AGENDA
PLANNING AND ZONING BOARD
VILLAGE HALL COUNCIL CHAMBERS
226 CYPRESS LANE ■ PALM SPRINGS, FL 33461
AUGUST 11, 2026
6:30 PM

3. **Minor Site Development Plan (SPR26-07) with five variances (PSV26-14 through PSV26-18) — Summit Square Retail Building — 4363 10th Avenue North:**
Staff: Christian Melendez Berrios, PZ&B Technician

ITEM #3: Minor Site Development Plan (SPR26-07) with five variances (PSV26-14 through PSV26-18) — Summit Square Retail Building — 4363 10th Avenue North

DATE: 7/20/2026
DESCRIPTION: Summit Square Retail Building
APPLICANT/AGENT: Luigi Vitalini/Vitalini Corazzini Architects
OWNER: Summit Square, LLC
APPLICATION TYPE: Development Order Amendment* (DOA)
REQUEST: Utility/Civil Plan and Landscape Plan Review
LOCATION: 4363 10th Ave., Palm Springs, FL 33461
STAFF REVIEW: **APPROVAL LETTER**

3 Bike Rack 3/4"

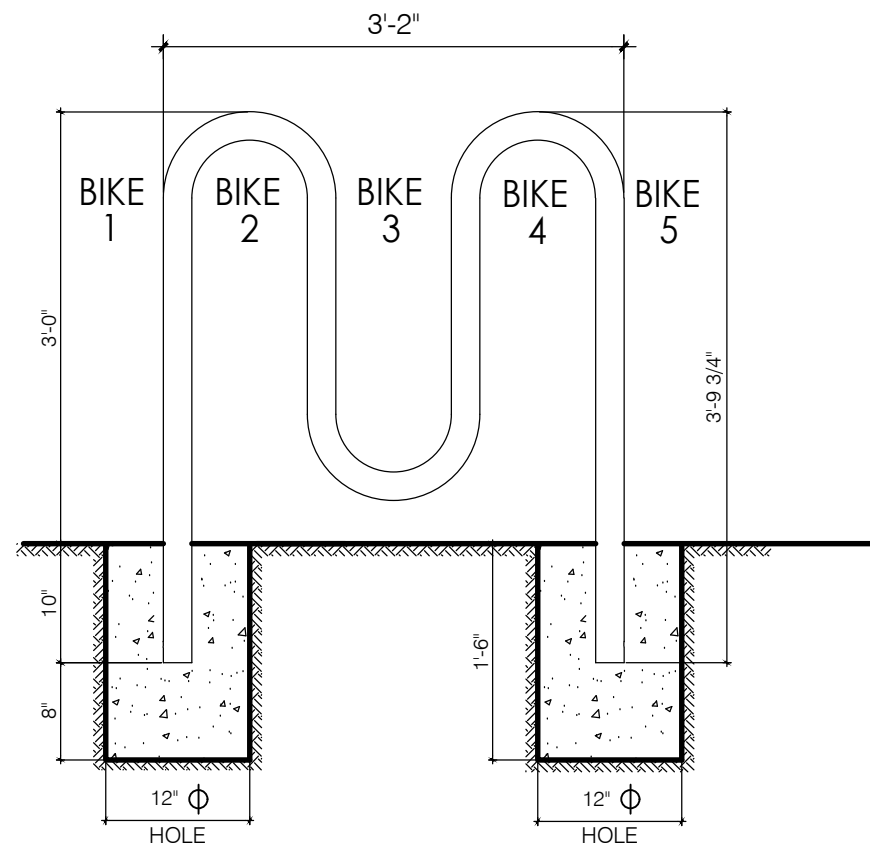
17. Provide an Auto Turn analysis for both a fire truck and a waste management truck.
Applicant response: See Rev_4363_Auto_TURN_EXHIBIT and Rev_4363_Auto_TURN_EXHIBIT(2).
Village Response: Comment Satisfied.
18. Provide details of the bicycle rack.
Applicant response: See B2103.00_ARCHITECTURALSET/A101.
Village Response: Comment Satisfied.
19. Provide details of the dumpster.
Applicant response: See B2103.00_ARCHITECTURALSET/A101.
Village Response: Comment Satisfied.
20. Provide details of the proposed white PVC fence.
Applicant response: See B2103.00_ARCHITECTURALSET/A101.

Village Response: Comment Satisfied.

LP-1

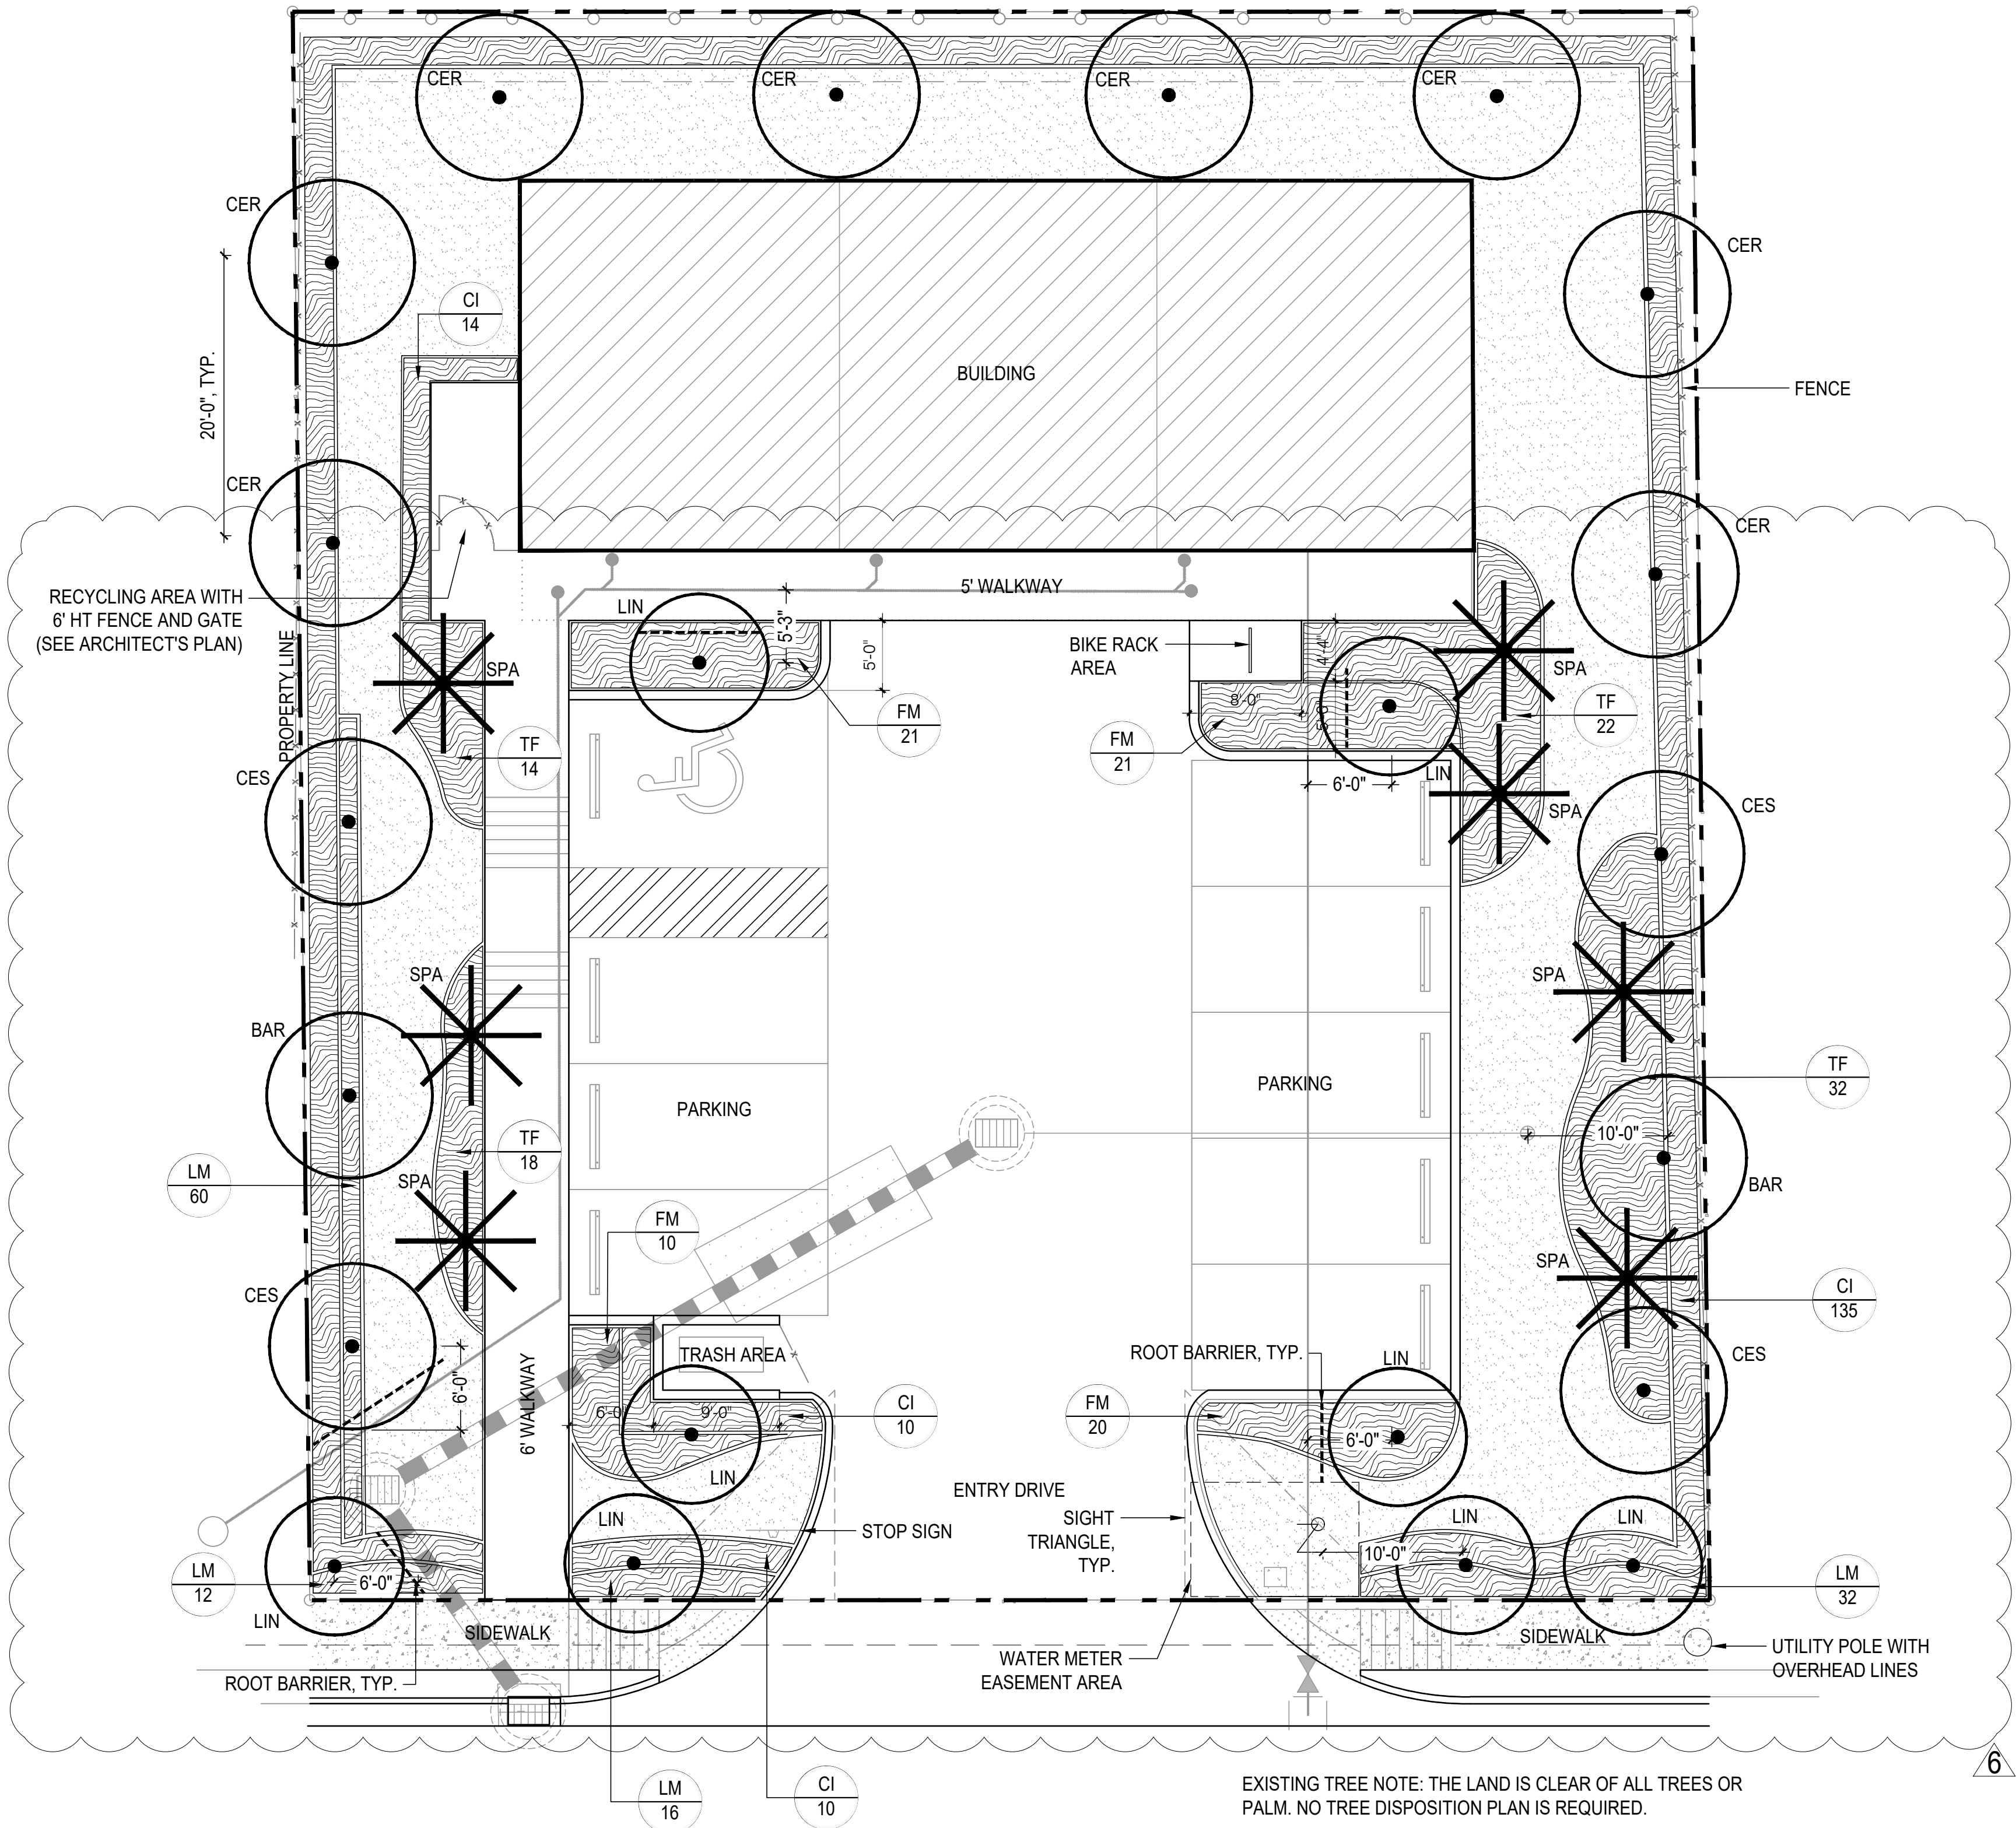
16. Show all underground utilities and storm drainage on Landscape plan, adjust any tree locations that may be impacted and provide root barrier where necessary.
Applicant Response: No response provided.
Village Response: Comment remains. No underground utilities have been shown on the Landscape Plan.
Applicant Response: Underground utilities and tree relocations available LP-1 REV5.
Village Response: Comment satisfied.

C-03

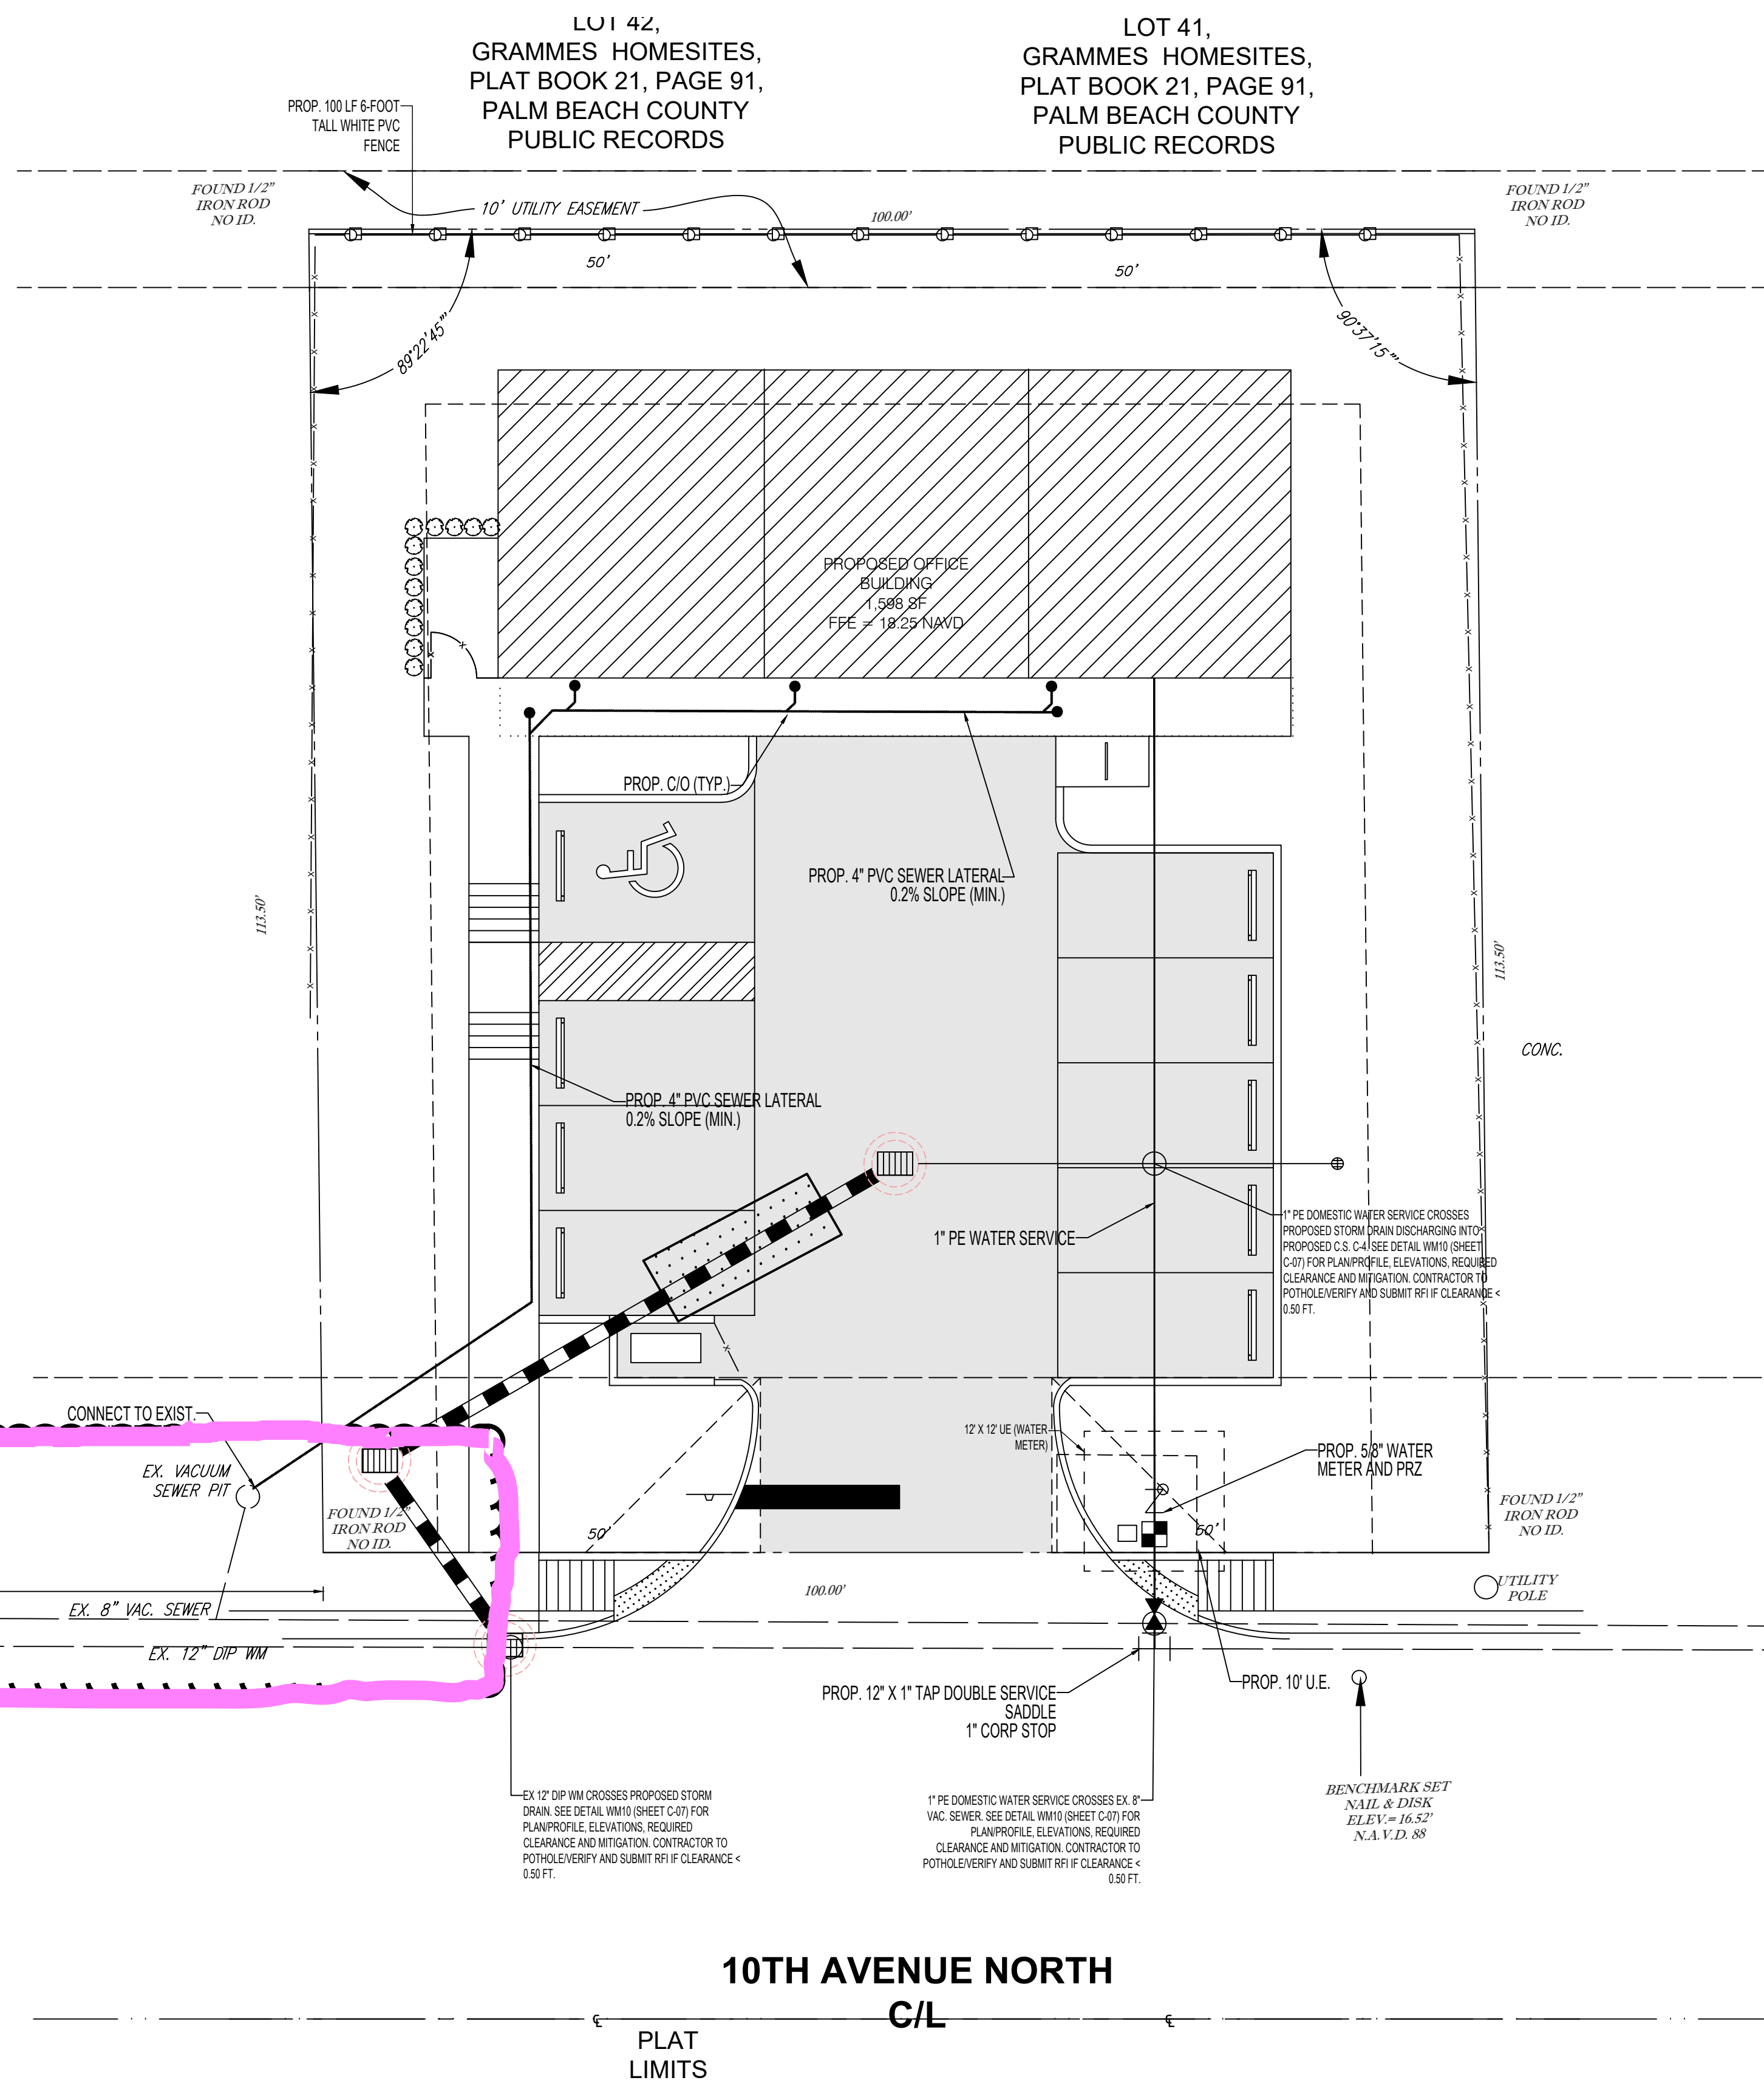
7. On Sheet C-03, provide a callout for the conflict between the 1" PE Water Service and the existing storm drain discharging into the PROPOSED C.S. C-4 CATCH BASIN.

8. On Sheet C-03, the existing 12" DIP WM runs perpendicular to the curb inlet on 10th Avenue North. Provide a callout for the conflict between this pipe and structure.

9. On Sheet C-03, provide a callout for the conflict between the 8" VAC. SEWER and the 1" PE WATER SERVICE.

Applicant Response: See Rev_4363_Utility Plan Sheet 3 of 4 Rev2.

Village Response: Comment satisfied.

Applicant Response: See Rev_4363_Utility Plan Sheet 3 of 4 Rev2.

Village Response: Comment satisfied.

Applicant Response: See Rev_4363_Utility Plan Sheet 3 of 4 Rev2.

Village Response: Comment satisfied.
